Technical Bulletin

Date: **8 January 2021**

Subject: **Assembly of the single-seat shell**

Product: **Superveloce Serie Oro** from vin ... LV001230 to vin ... MV001908

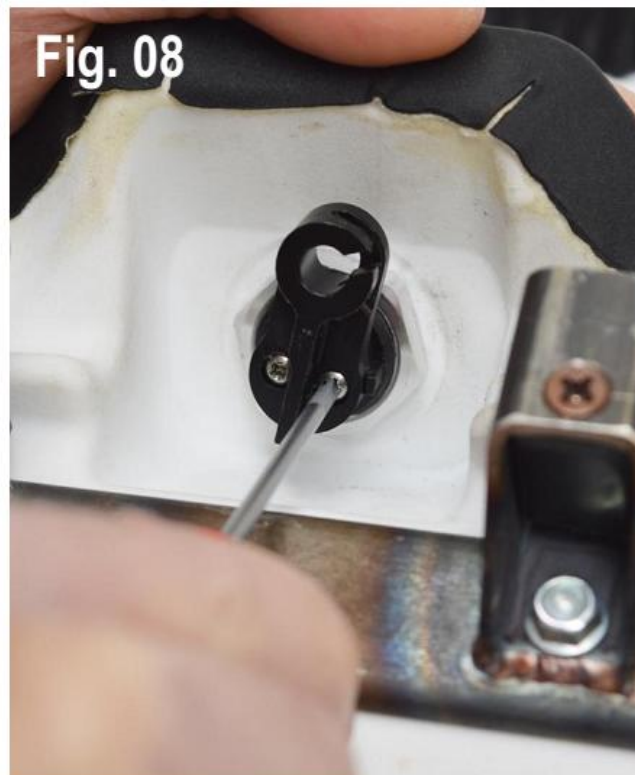
- Remove the lock cod. 8000B9254, unscrew the 2 fixing screws and remove the plate (See Fig. 01).
Note: Do NOT re-use the plate.
- Unscrew and remove the lock fixing nut (See Fig.02). Note: Do NOT re-use the nut.

- Position the lock flange (code 8000C8031) in its seat on the single-seat cushion, paying attention to match the shape of the holes of the two components (see Fig.3).

Fig. 12

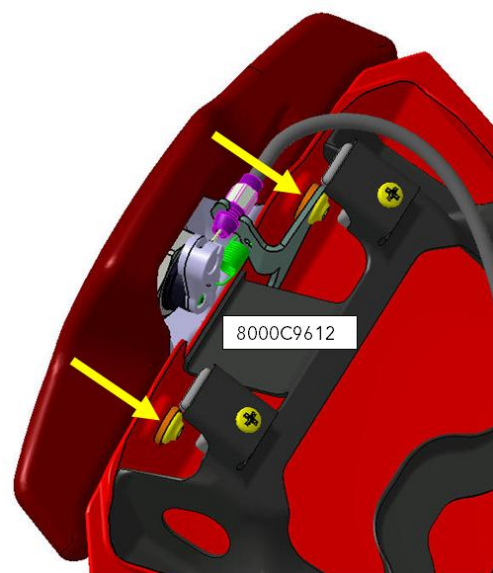
- Tighten the lock nut by turning it of an extra + 30 ° rotation using a 26 mm (See Fig. 09).
- Mount the cushion on the shell using the 3 body screws 8D00B5919 and the 3 spacers 8000C9612 as shown in the figure. The spacers must be positioned in contact with the shell.
- The transmission retaining plate (code 8000C8419) must be installed on two of the three fixing points of the cushion (See Fig.10).
- Insert the pawl of the lock transmission cable into the hole in the lever. Insert the rubber collar of the transmission cable in the retaining plate (See Fig. 12).

Fig. 13

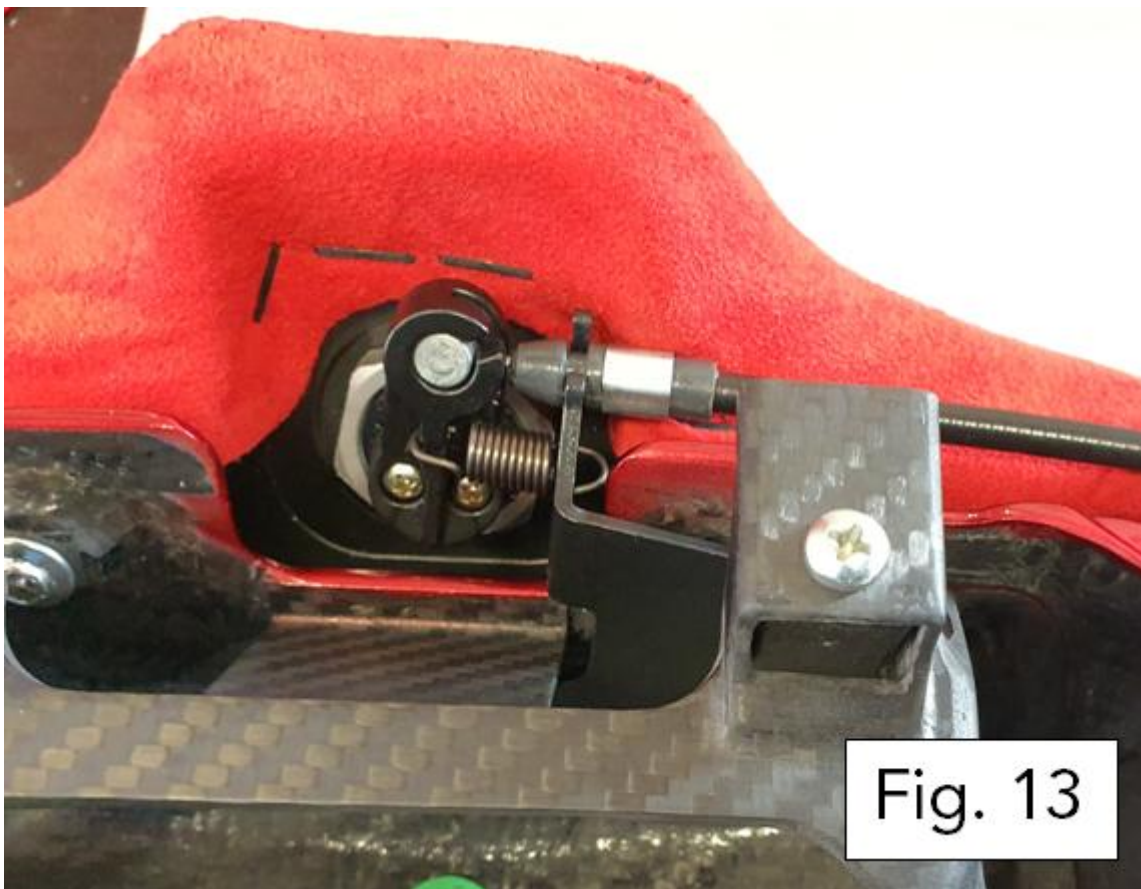
- Take 1 return spring (code 800027103). Attach a spring hook end to the lever and the other hook end on the retaining plate (see Fig. 13)

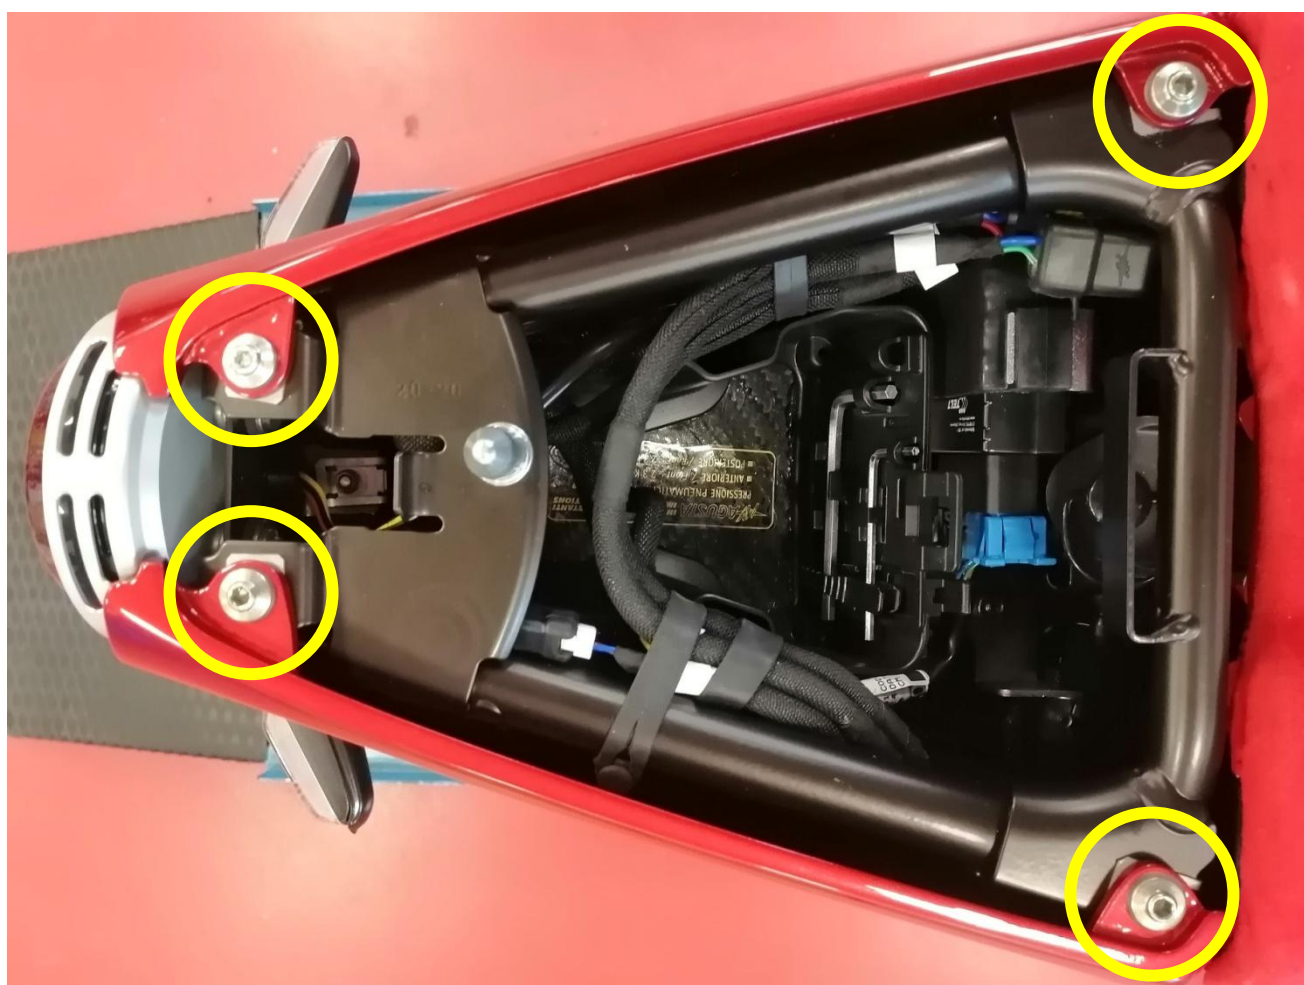
- Install 2 clip nuts 8000B5811 on the shell, and secure the lock bolt by inserting and hand tightening 2 TSEI M5x20 screws (code 8E00B2694) (See Fig. 20)

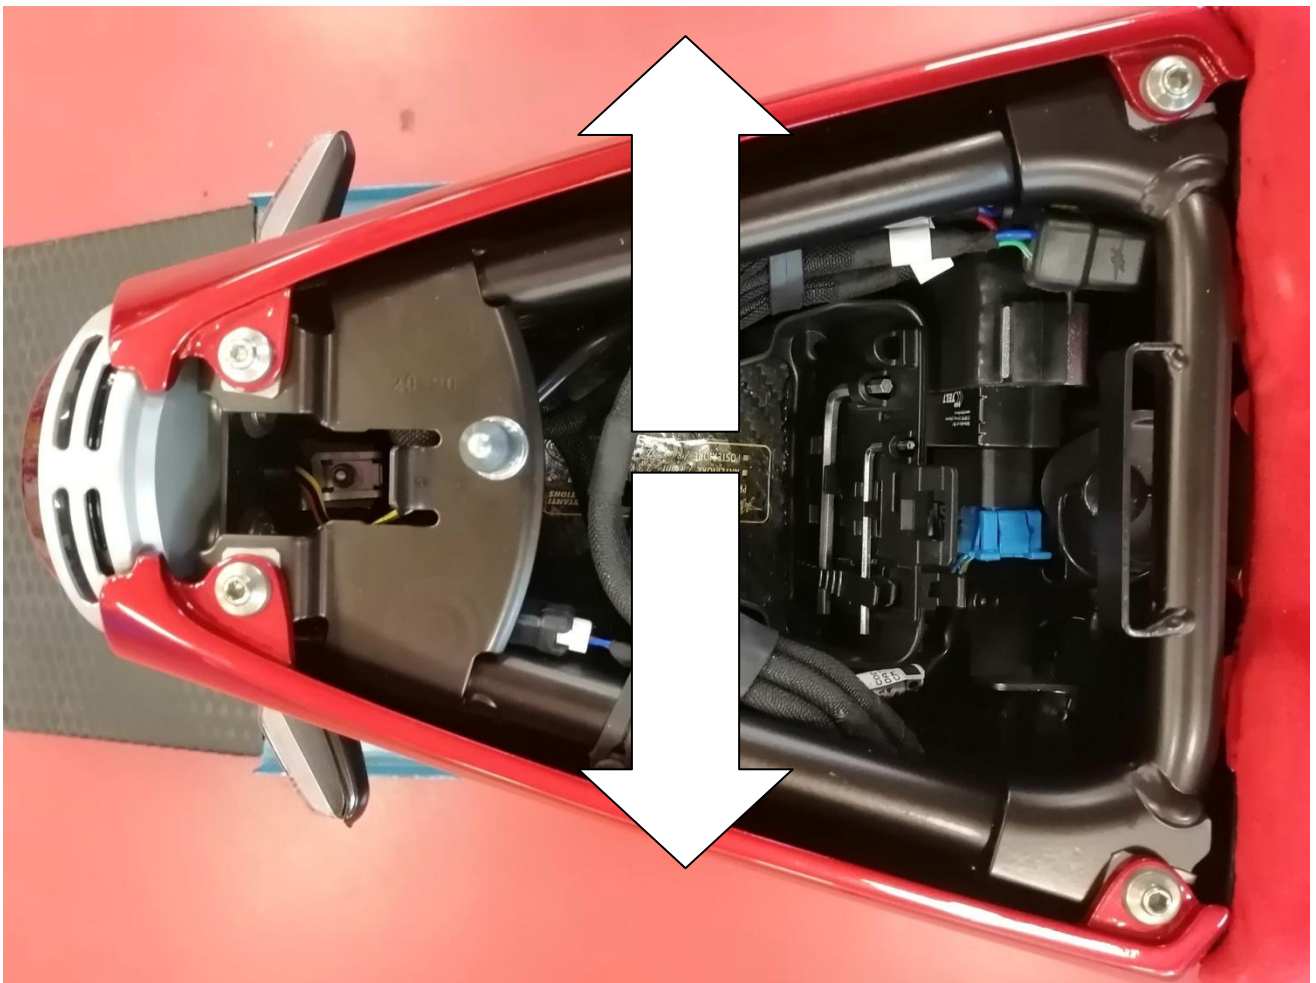
- Before reassembling the single-seat shell on the motorcycle, loosen the 4 fixing screws of the tail fairings in the upper part, until the collar of the screws comes out of the plastic seat of the fairing; the aim is to have the possibility to modify the position of the fairings of the tail:

- Once the screws have been loosened, proceed to carefully make the rear fairings as wide as possible, bringing them outwards:

- While keeping the fairings as wide as possible, re-tighten the 4 fixing screws previously loosened to a torque of 8 Nm
